Technical Permitting Workshop Containment Plans August 30, 2011

by Bryan Domangue

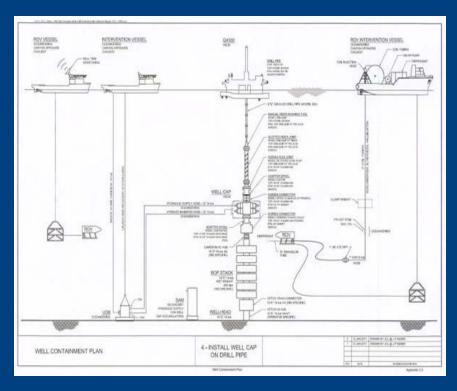
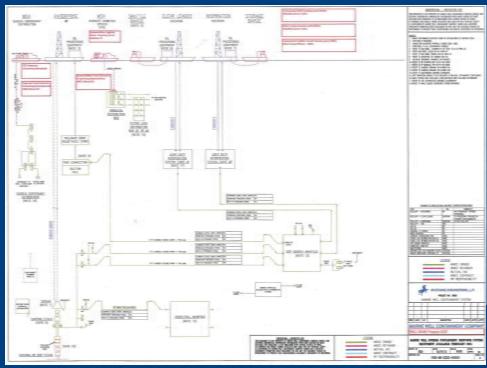
• Not providing a operator/well specific response PFD (Process Flow Diagram). Each plan should include a PFD that is specific to each operators' response capability. The generic version provided by MWCC and HWCG should be updated to be company specific.
